**CITY OF WINTER PARK  
PLANNING AND ZONING BOARD**

**Staff Report  
July 11, 2017**

**REQUEST OF DESHPANDE, INC. FOR:** APPROVAL OF THE FINAL PLAT TO CREATE A 30 LOT, RESIDENTIAL SINGLE FAMILY SUBDIVISION FROM PROPERTIES ON ELLEN DRIVE AND COUNTRY CLUB DRIVE, ZONED R-2.

# LAKE KILLARNEY SHORES

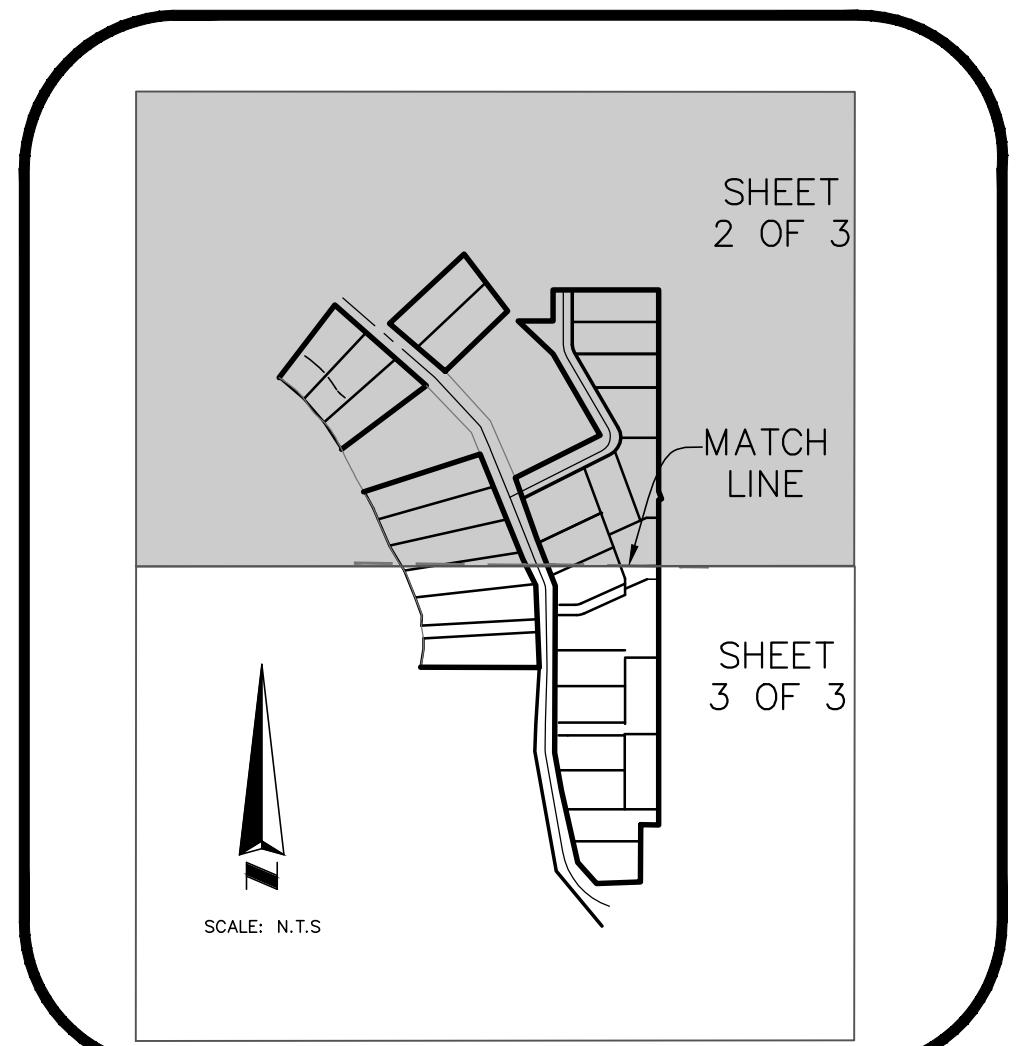
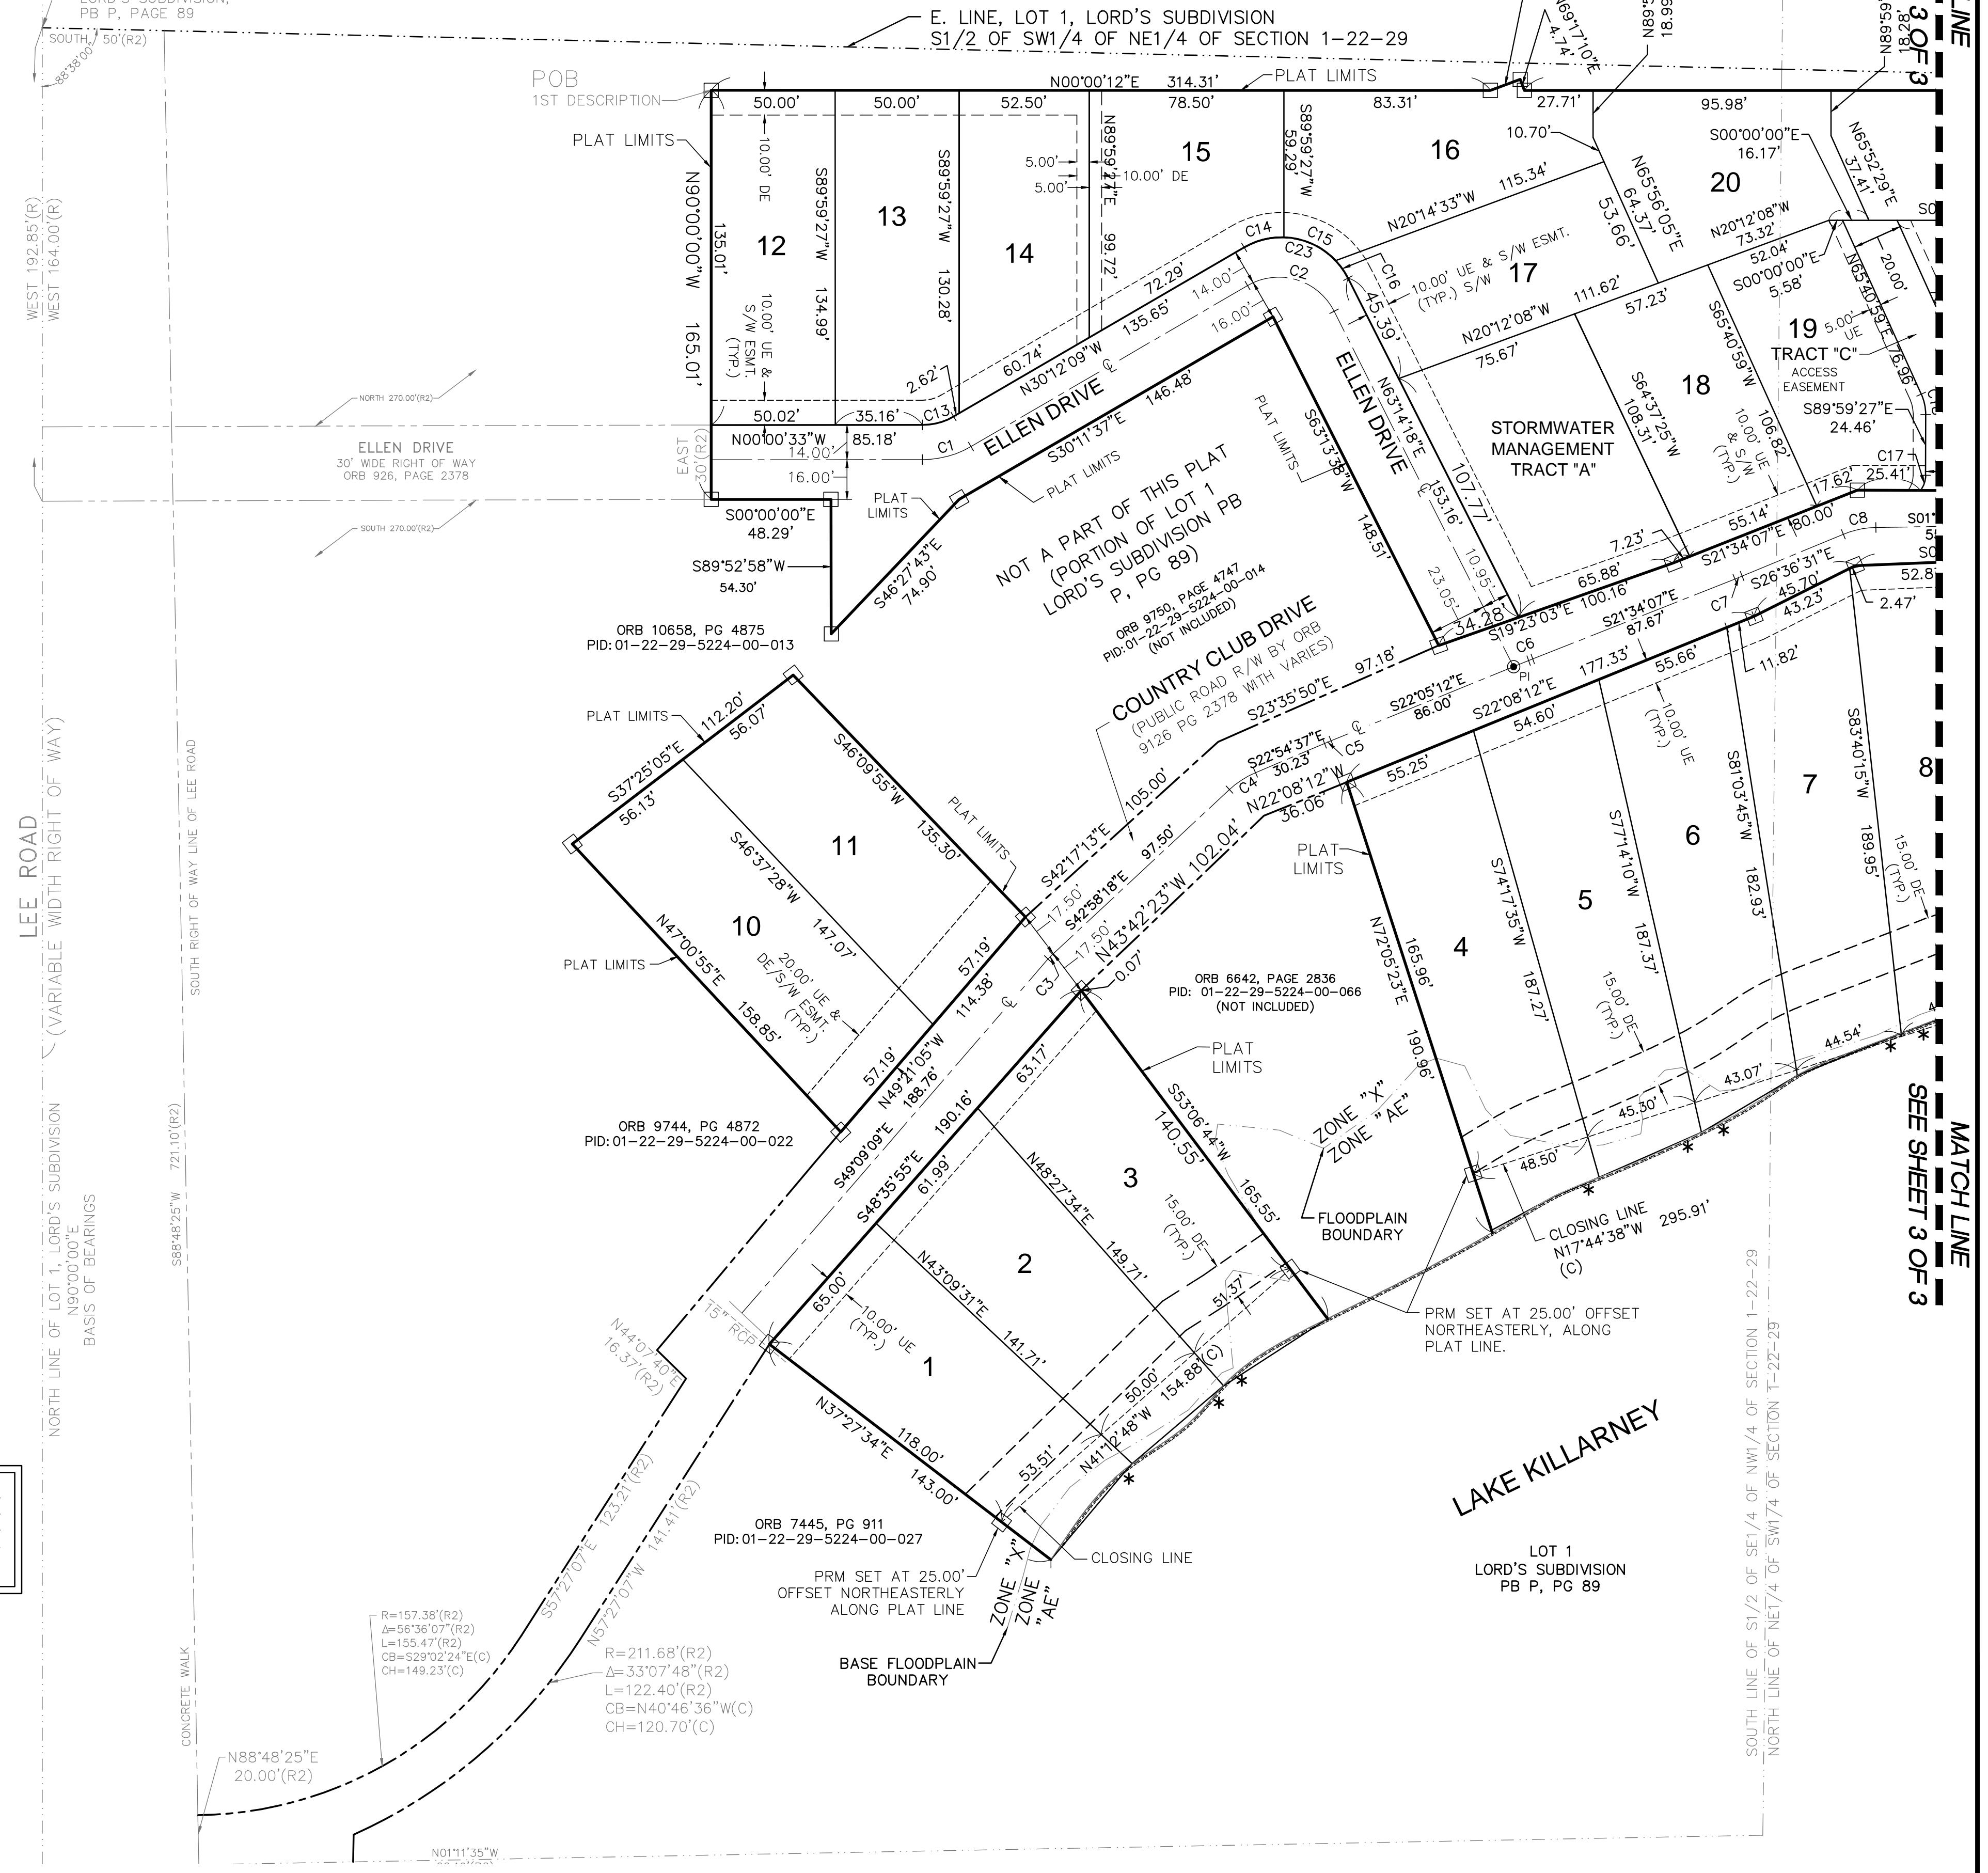
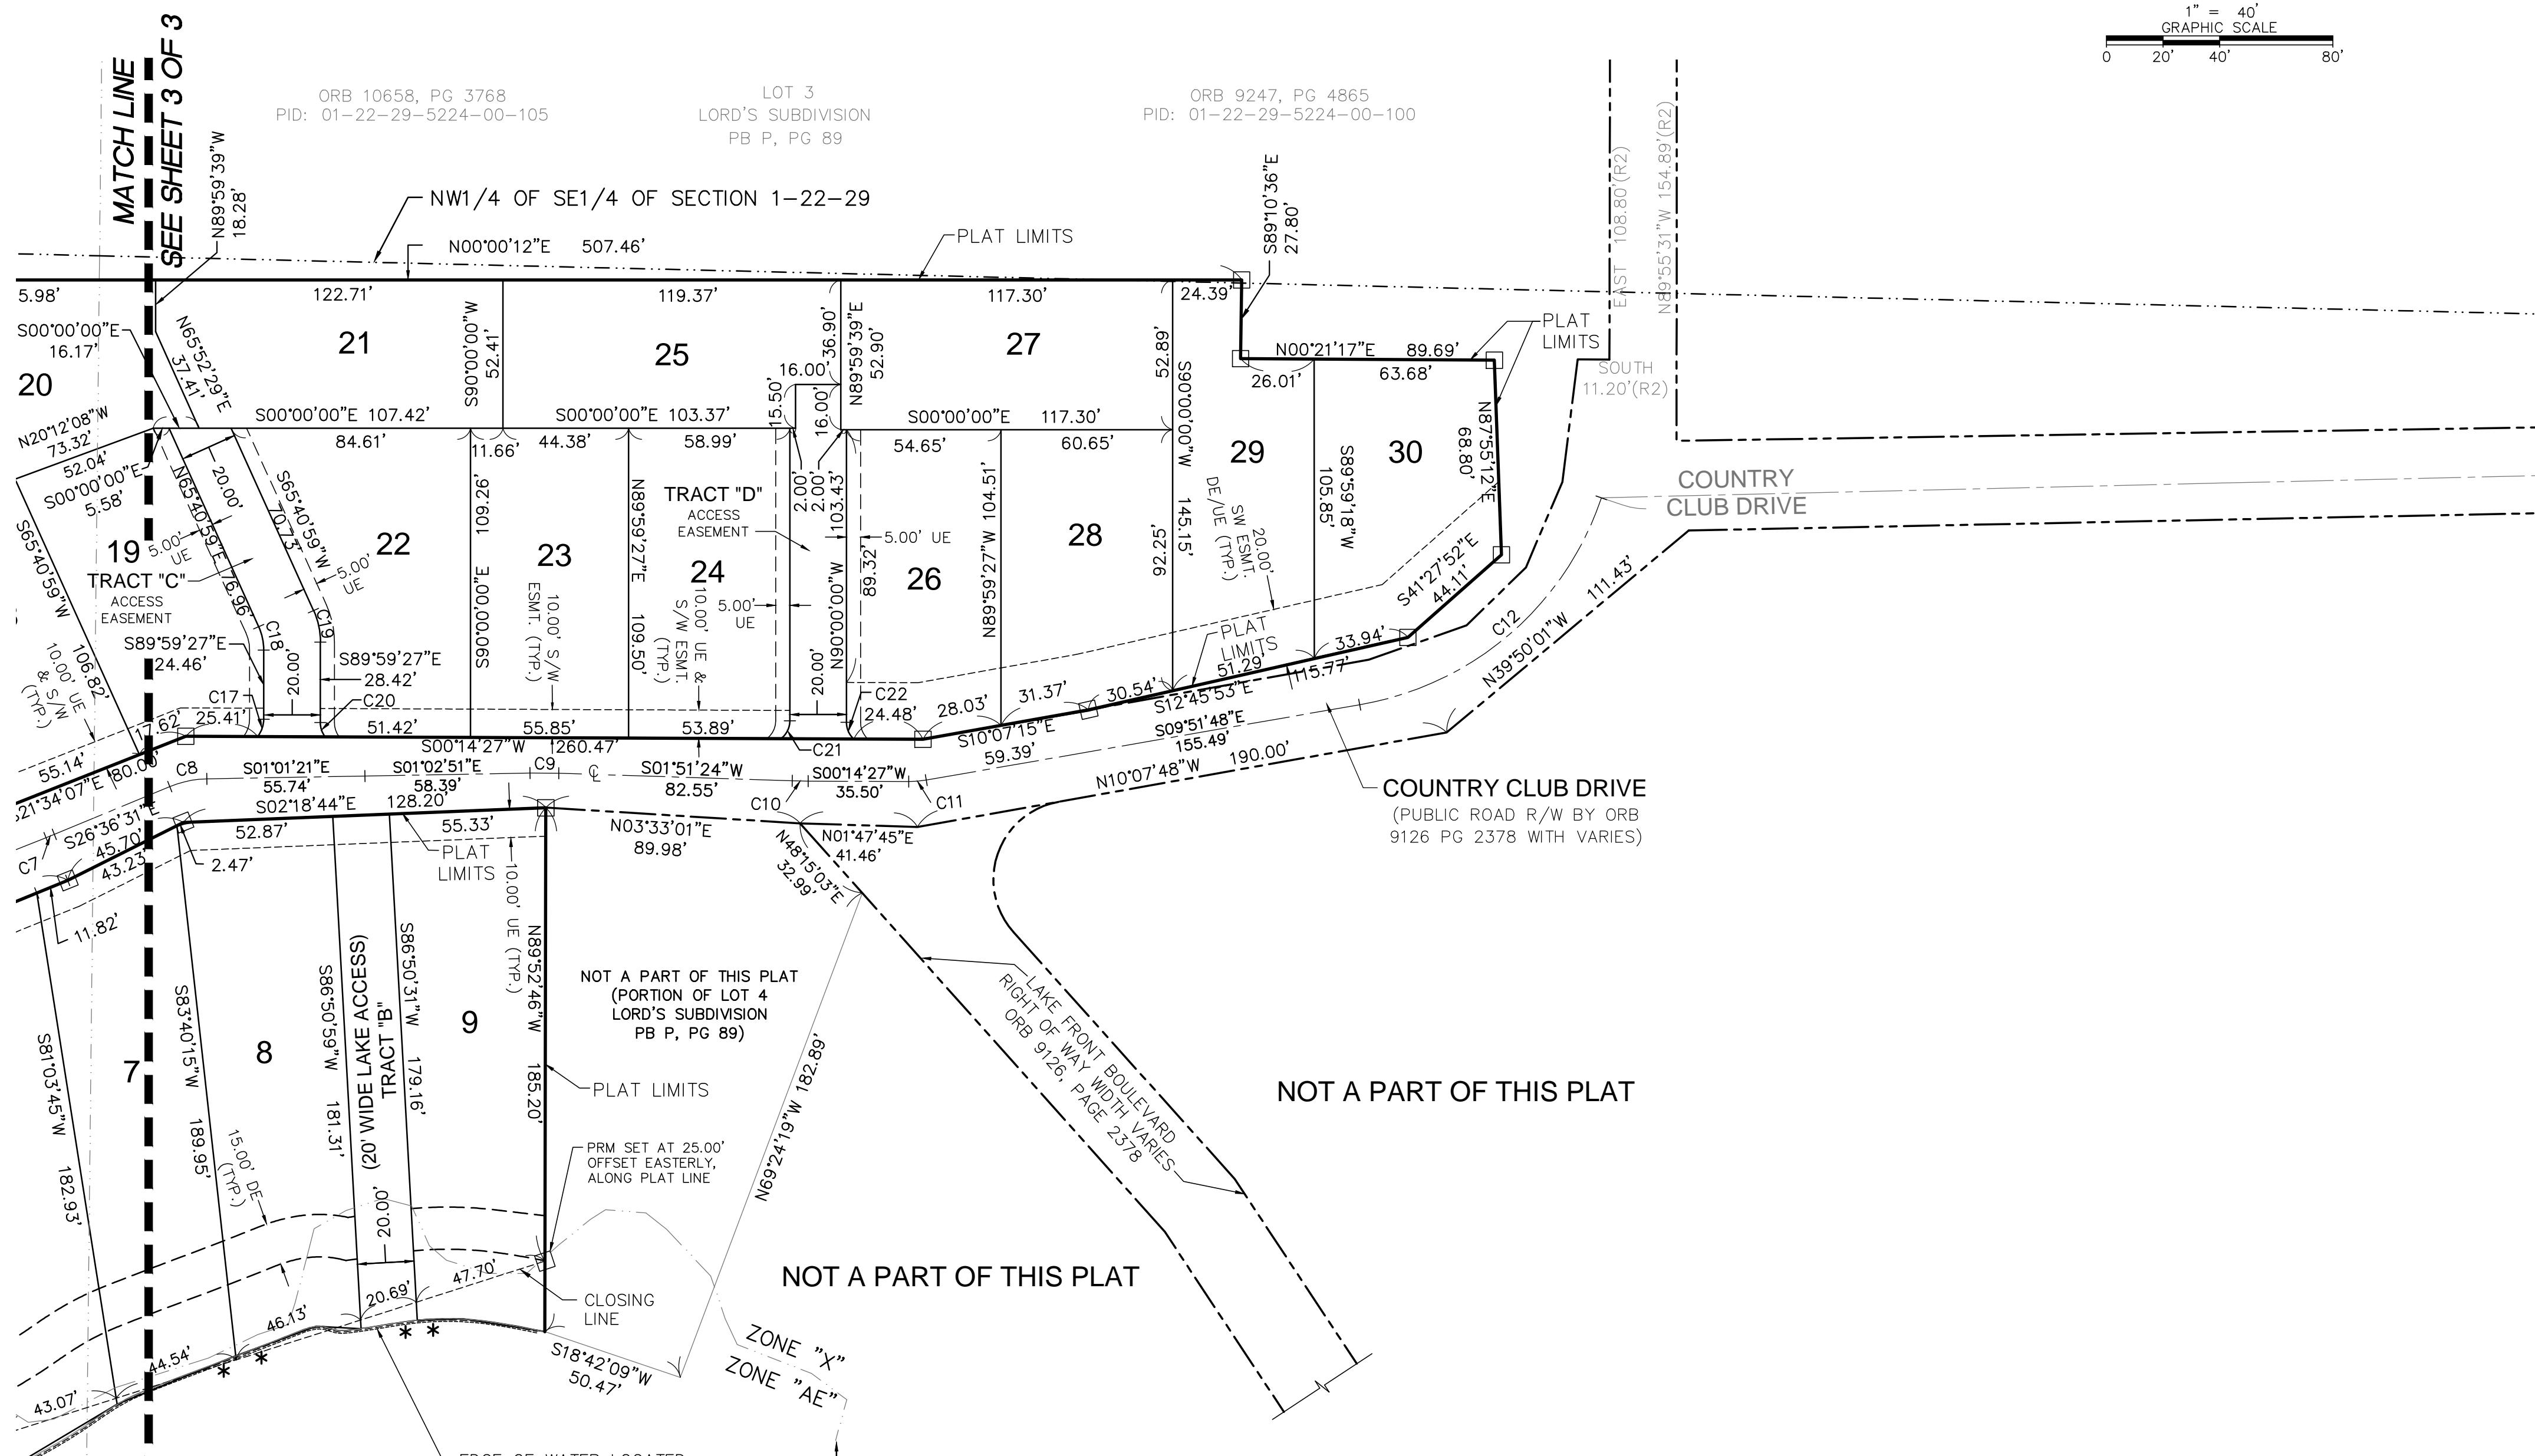
With regard to the construction of the new Ellen Drive roadway, the physical limitation of a roadway, curbs, utilities, etc. in a 30 foot right-of-way limited the ability to preserve trees. However, while 8 oaks are to be removed, those all are laurel oaks that are not in very good condition or appearance. On the northern portion of Ellen Drive there is the opportunity to preserve four of the oak trees including the one oak tree in the best condition.

With regard to tree preservation, on the non-lakefront building lots #10-#30, you will note that Condition #3 indicated that "preservation of specimen trees may alter the final lot design and building yield at the Final Plat stage". The attached plan titled "Trees To Be Saved" provided by the applicant now shows the specific trees to be saved for this neighborhood on the non-lakefront lots. In some cases there may need to be some interior setback relief in order to design a home to save the tree(s) and canopy. That setback relief proposed would be a 5 foot side setback in lieu of the required 10 feet and a second story setback of 15 feet in the rear in lieu of the required 25 feet. Staff will suggest a condition "that when deemed necessary by Urban Forestry in order to preserve tree(s) and canopy, that the building setback to an interior property line (in the same ownership) may be reduced to 5 foot side setback in lieu of the required 10 feet and a 25 foot second story rear may be reduced to 15 feet". This means that the trees shown in green will be preserved. It is the responsibility of the developer's and lot owner's design team to design a home to accomplish that preservation. However, the setback relief is provided just in those circumstances in order to save trees but otherwise the homes will be designed to the normal R-2 setback standards.

4. That the Final Plat contains the designation of mandatory boathouse/dock locations and the Plat shall indicate such and that the side setback may be one foot to the structure and zero to the roof eve and that the maximum width of any boathouse/dock shall be 16 feet and maximum distance into the lake shall be 30 feet from the ordinary high water elevation.

5. That this Final Plat approval recognizes that requirements for the preservation of specimen trees may alter the final lot design and building yield square footage and that the maximum permitted floor area ratio is not an entitlement to the affected building lots on the "Trees To Be Saved" plan presented by the applicant identified as Lots #10 through #30.

6. That the tree(s) and canopy of the shade trees shown in the "Trees To Be Saved" plan shall be preserved. However, when deemed necessary by Urban Forestry in order to preserve tree(s) and canopy, the building setback to an interior property line (in the same ownership) may be reduced to 5 foot side setback in lieu of the required 10 feet and a 25 foot second story rear may be reduced to 15 feet. No permit for removal of these trees will be granted by the City for a period of at least 25 years from the date of recording of this Plat unless the City Arborist determines that their condition, health or other non-economic factors warrant their removal.
